GC32 CLASS RULES 2016 - BUILDER SPECIFICATION UPDATE NO 1

New traveller line end stop on aft beam

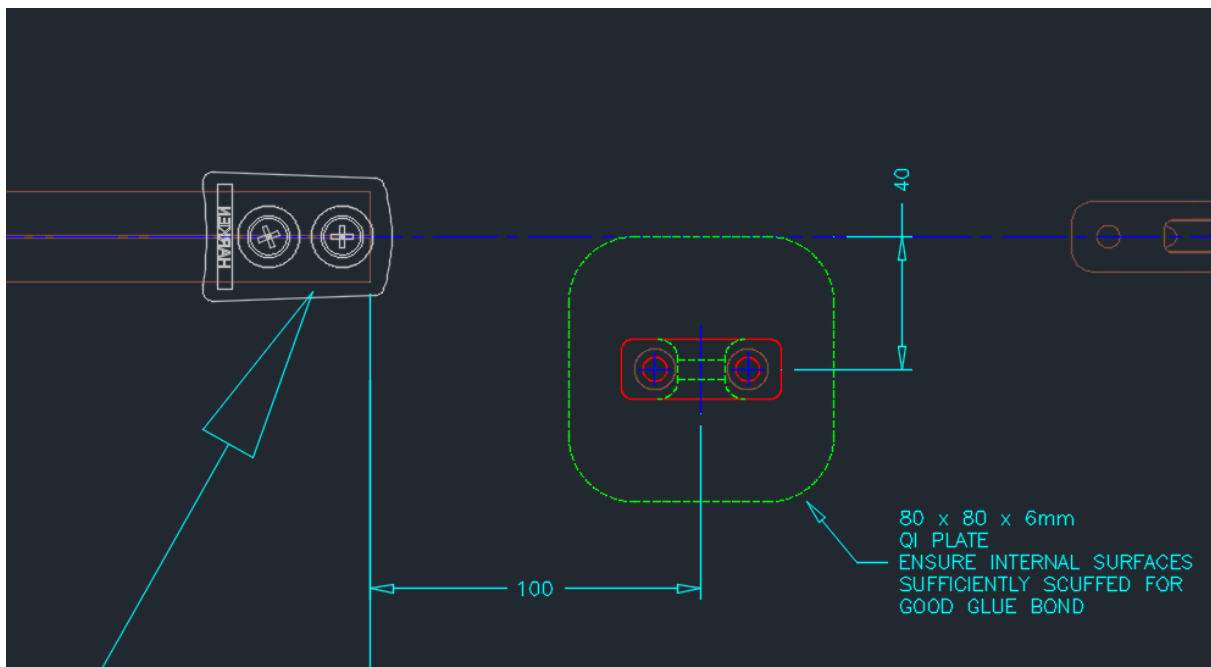
The old system with **2 x 27mm ESP End Control Dead-End 3:1** on the traveller track the has been replaced by **2 x 27mm Track Endstops** and **2 x 14.14 Antal Deck Ring** mounted on the aft beam with a carbon back plate. The 14.14. Deck Ring have to be mounted according to the drawing below.

All boats from build no 12 onward are supplied with the new traveller line end stop system. This system shall not be changed. Older boats are allowed to used their originally supplied system or can upgrade to the new system according to the builder specification and detailed drawings.
